Amendments to the Drawings

REMARKS

Fig 5

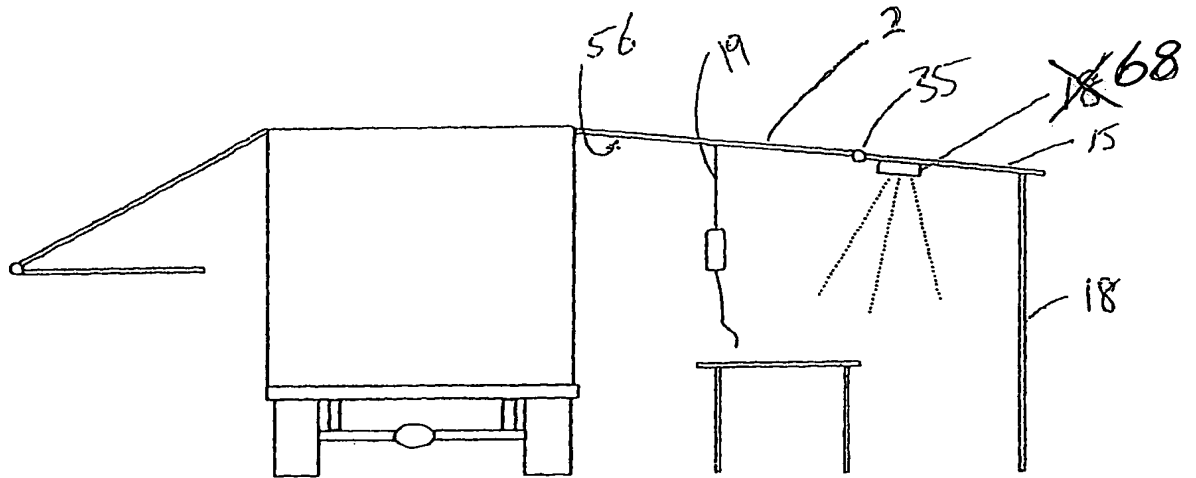
Fig. 5 is amended to correct the numeric identifier for the light source to “68” in correspondence with the text at page 6, paragraph 84.

The drawings stand objected to as failing to comply with 37 CFR § 1.84(p)(4) due to the numeric identifier “18” being utilized to designate both the light source and the post in Fig. 5. A corrected drawing sheet is submitted herewith in accordance with 37 CFR § 1.121(d). In the corrected drawing sheet the numeric identifier for the light source has been corrected to “68” in correspondence with the text at page 6, paragraph 84.
